Re: Villa Senderos Subdivision Grading and Drainage Plan
Engineer's Stamp dated 2-11-09 (G10/D007A)

**Re: RESPONSE TO COMMENTS FOR VILLA SENDEROS SUBDIVISION
(G-10 – D007A)**

DRAINAGE REPORT
FOR
VILLA SENDEROS SUBDIVISION

RE: **VIA SENDEROS SUBDIVISION** – College Park West, Tract F (G10 – D 007 A)
Drainage Plan for Building Permit (PE Stamped 05-29-08)

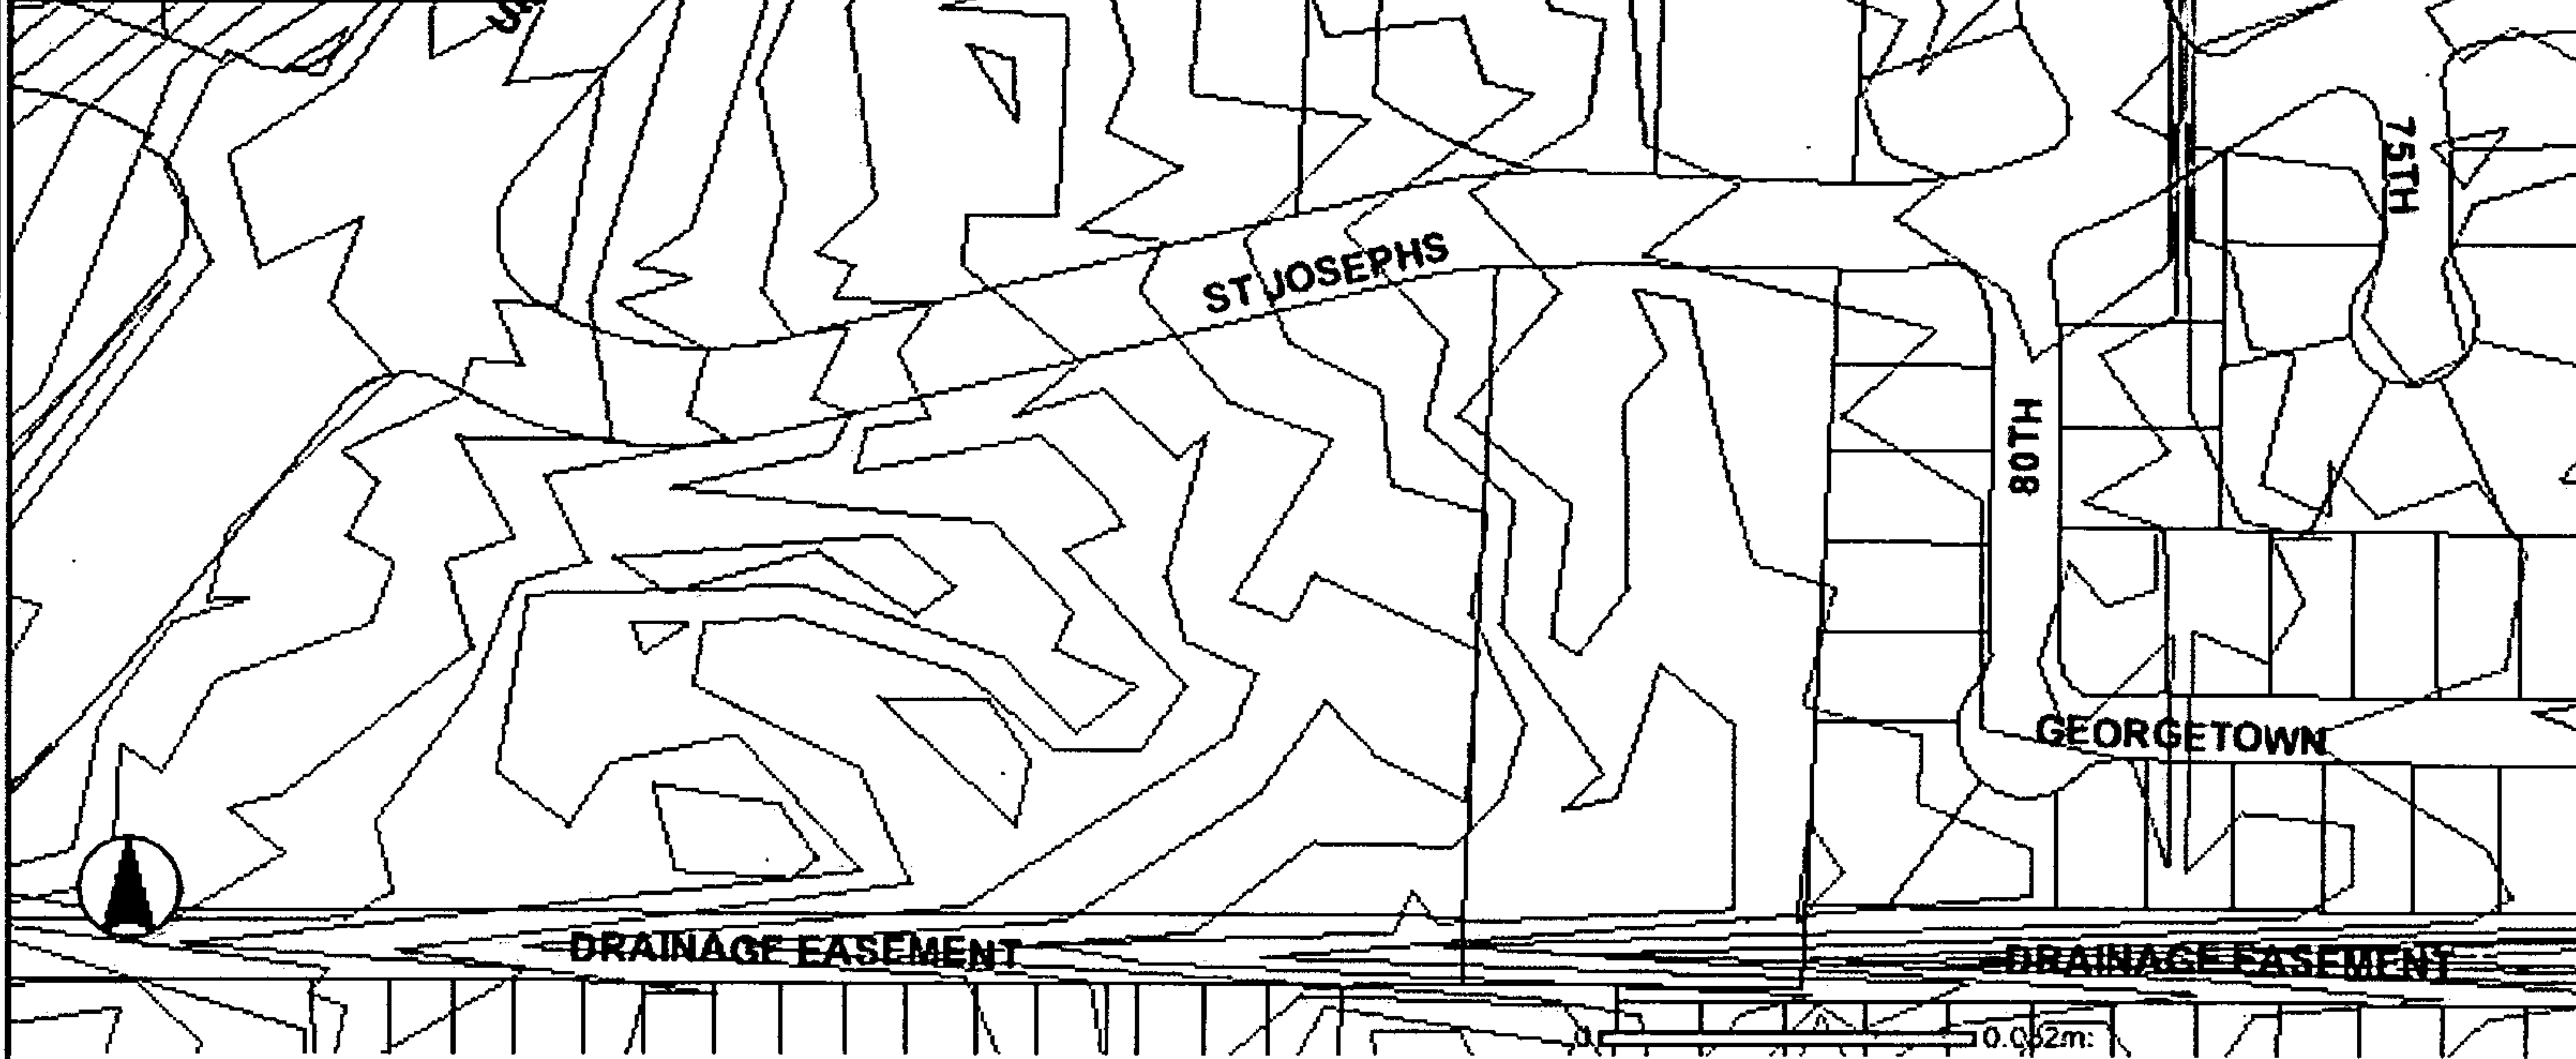
- Take w/ Dave 2-9-09, ok to drain all out to St. Josephs because a majority of tract E will go to the channel*
1. The Drainage Report indicates no offsite flows reach the site, however contours on the grading plan show at least some of Tract E draining into Tract F from the west. Quantify these flows and address handling them with development of Tract F.

2. The Master Drainage Plan prepared by Espey-Huston & Assoc. for College Park West also proposed surface discharge of Tract F to St. Josephs Ave., but at a developed rate of 6.03 cfs, Q_{100-6 Hr.} Your proposed rate of 8.82 cfs must be reduced to the 6.03 cfs rate, **-OR-** you must provide analysis to show that surface flow capacity exists downstream through the rundown on 67th Street, to convey this increased rate.

3. Clarify the intent for the "Undeveloped" Parcel, Lot A. Will it be graded? Provide stabilization to keep sediment from entering the public R/W on Tallado Court.

4. Provide a typical street cross section for Tallado Court and/or contours on Lot A to clearly show and ensure the erosion control requested in item 3, above.

5. In the typical Lot Grading Plan, where is dimension "D1" and should the last note end with a reference to "SPOT ⑥" ?
 6. Since the site is 2.7 acres, remember that a SWPPP will be required.

1. The revised drainage report identifies a small offsite basin that drains onto Tract F from Tract E. The offsite flows will be retained in a temporary retention pond until Tract E is developed in the near future.

2. The peak discharge from Villa Senderos to St. Joseph's Avenue has been reduced to 7.40 CFS, which is still greater than the 6.03 CFS discharge allowed in the College Park West Master Drainage Plan. The difference will be made up when Tract E is developed by the same owner and developer. A portion of Tract E that currently drains to St. Joseph's Avenue will be directed to the Rinconada Channel. A minimum of the 1.37 CFS peak flow from Tract E will be drain south to the Rinconada Channel.

3. the north portion of Tract A will be graded to temporarily retain onsite and offsite runoff. The southern portion of Tract A will have one-foot high earthen berms to provide protection to Tallado Court and to the Rinconada Channel.

4. Contours on Tract A have been provided on the revised grading plan.
5. The typical lot grading plan detail has been revised accordingly.
6. We are aware that a SWPPP will be required for the subdivision.
